Bid Bulletin #5

PROJECT: Kearney High School, Kearney, Nebraska
Bid Package #3

DATE: October 16, 2014

Item 5-3: Attached is a copy of Addendum #4 from Wilkins, Hinrichs, Stober Architects LLC dated October 16, 2014.

PLUMBING LARGE SCALE PLANS

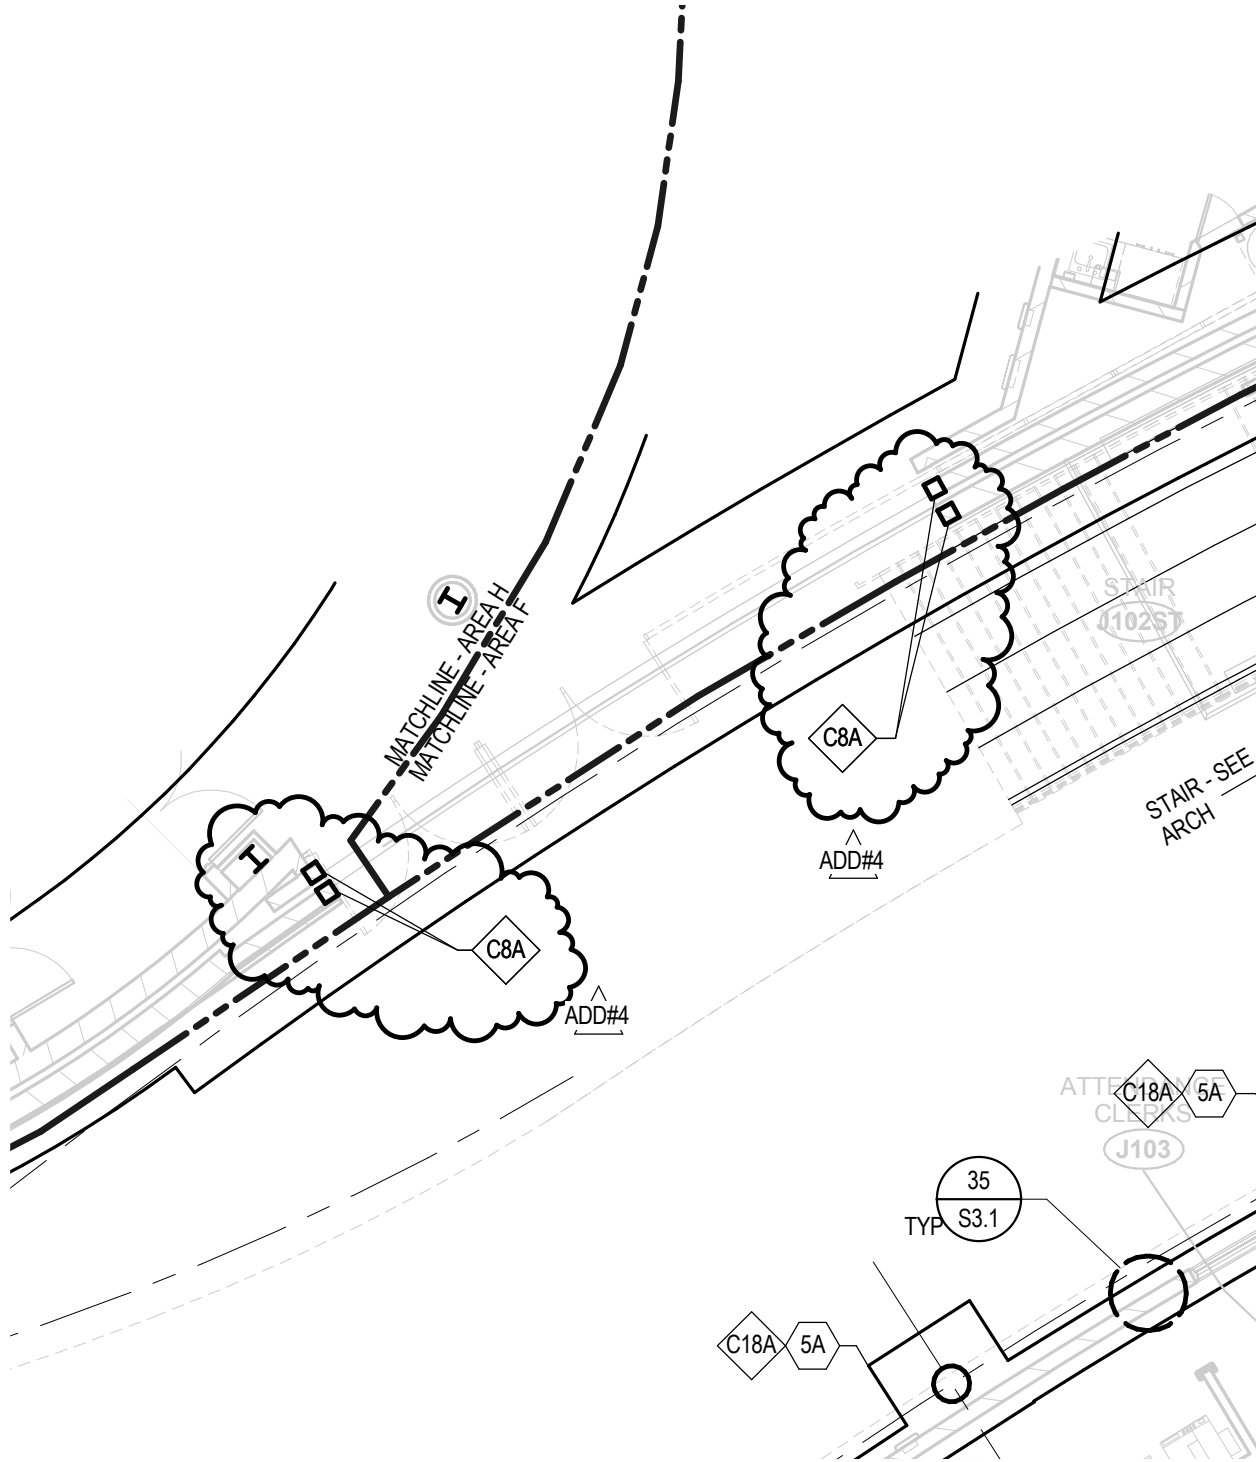
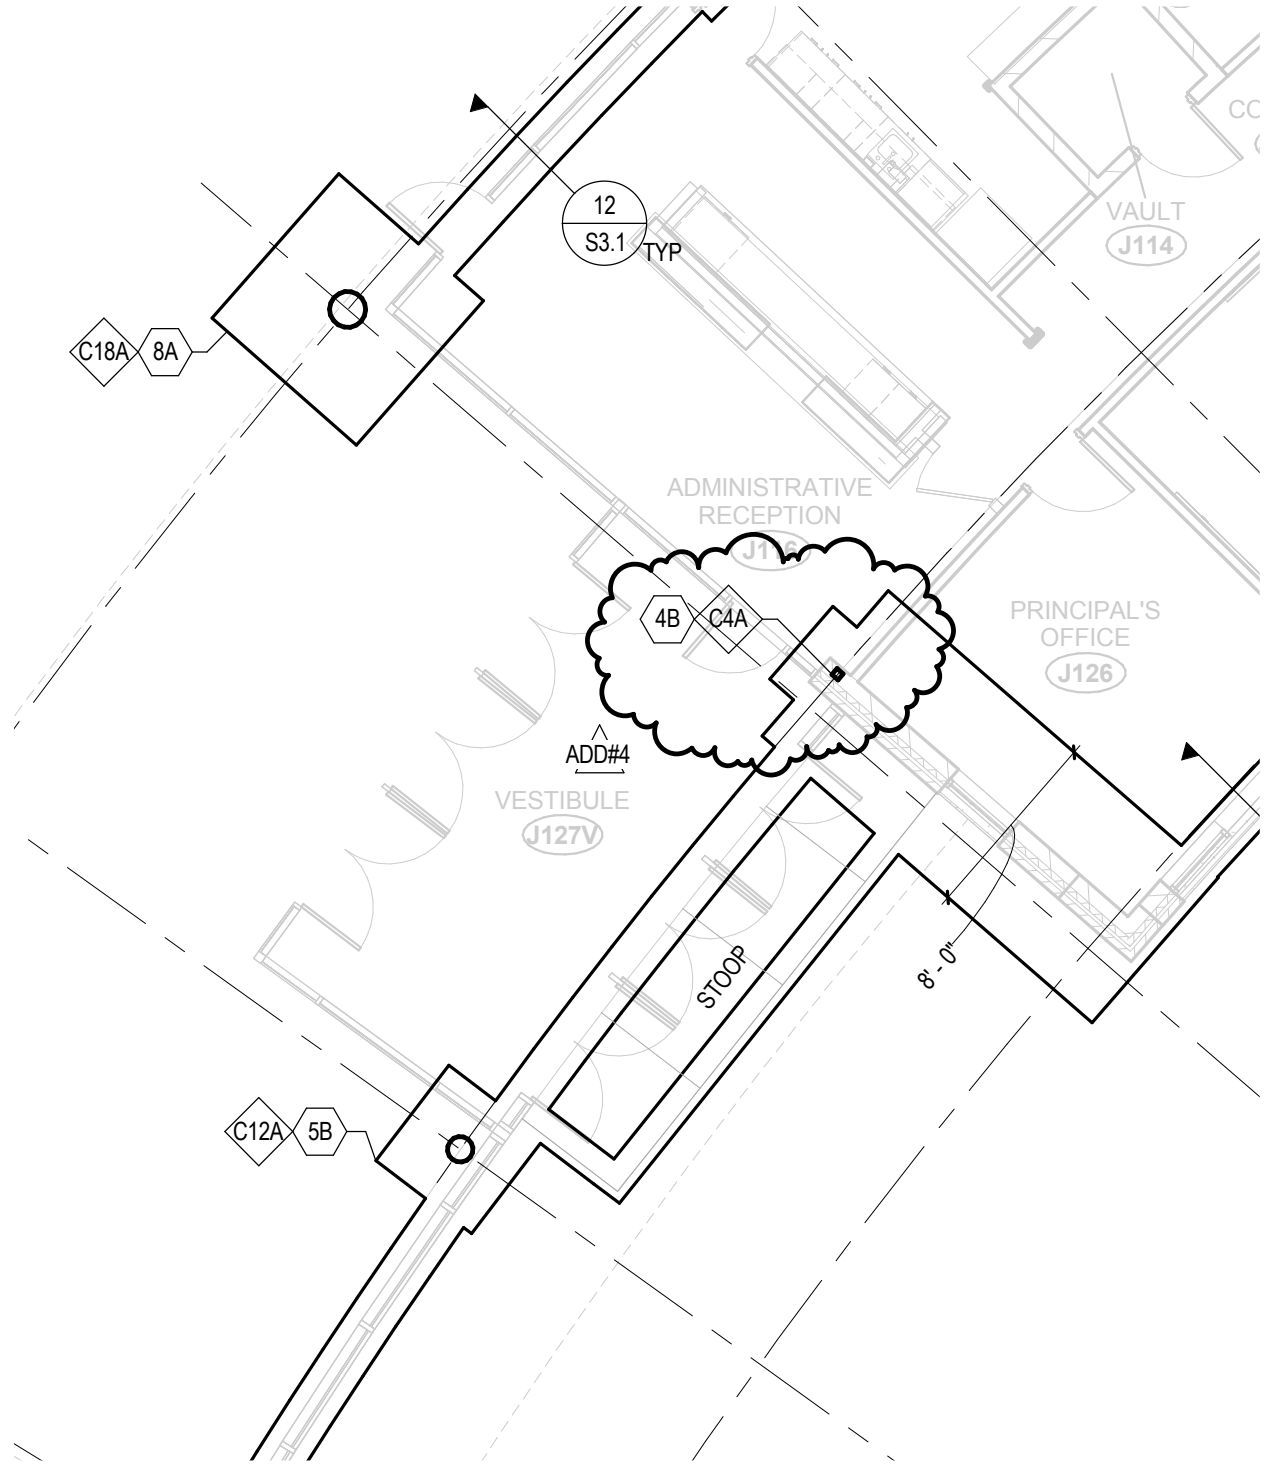
- Addendum #4 - #49 SHEET P2.5 – PLUMBING LARGE SCALE PLANS**
Delete Drawing in its entirety and substitute P2.5 – PLUMBING LARGE SCALE PLANS.
- Addendum #4 - #50 SHEET S1.8 – FOUNDATION PLAN – AREA J**

Attachment No. S1.8-1
to Addendum No. 4
Dated: October 16, 2014

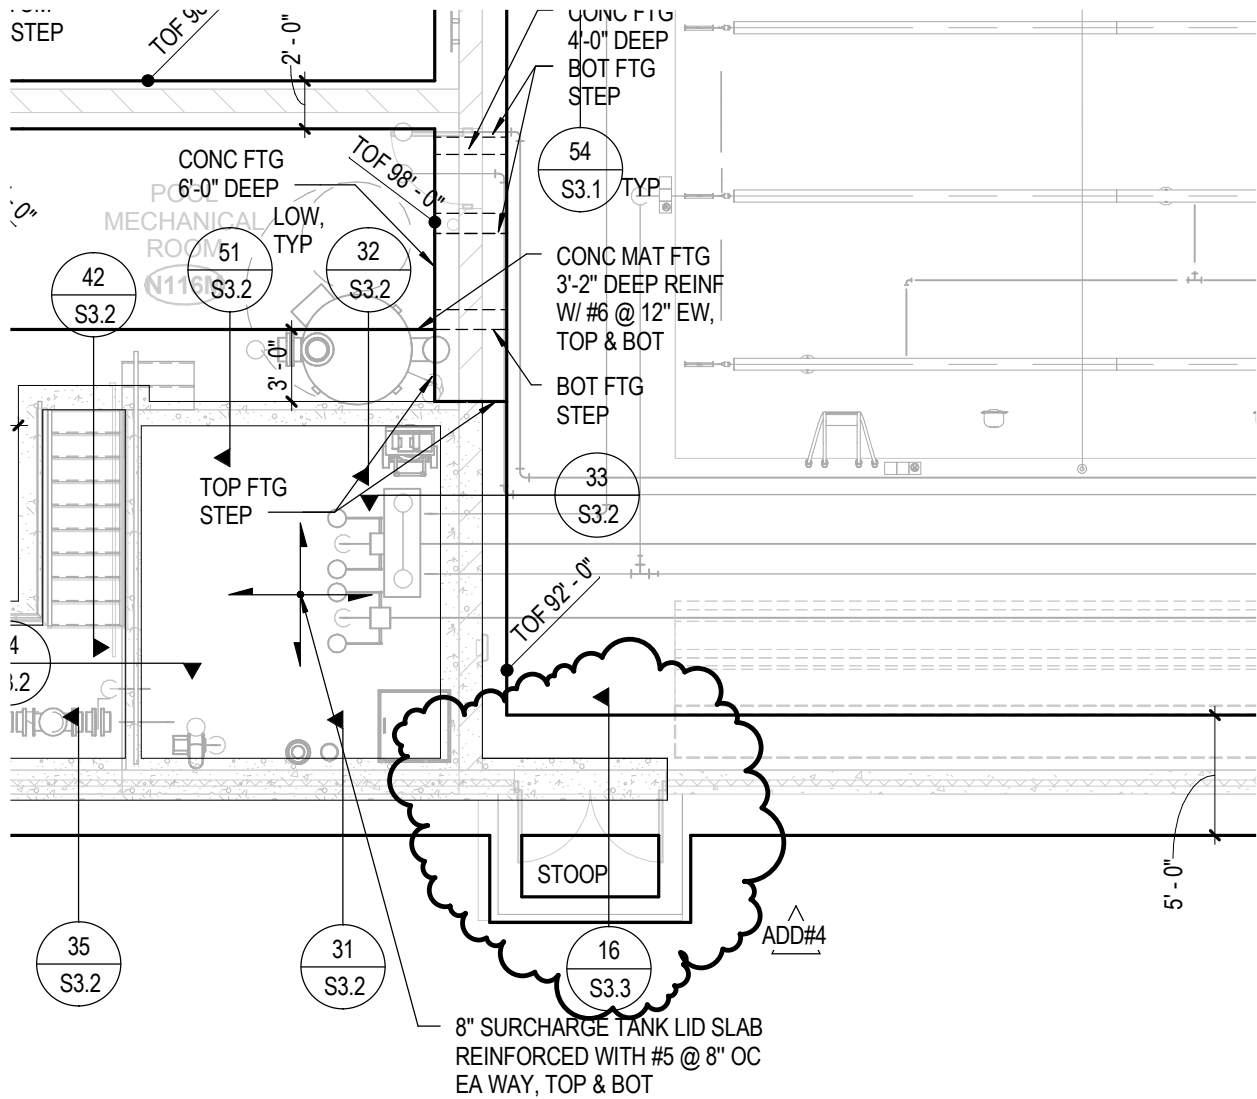
- a. Modify Drawing as shown on attachment S1.8-1 to Addendum No. 4, dated October 16, 2014. Drawing modified to add column tags.
 - b. Modify Drawing as shown on attachment S1.8-2 to Addendum No. 4, dated October 16, 2014. Drawing modified to add column and spread footing tags.
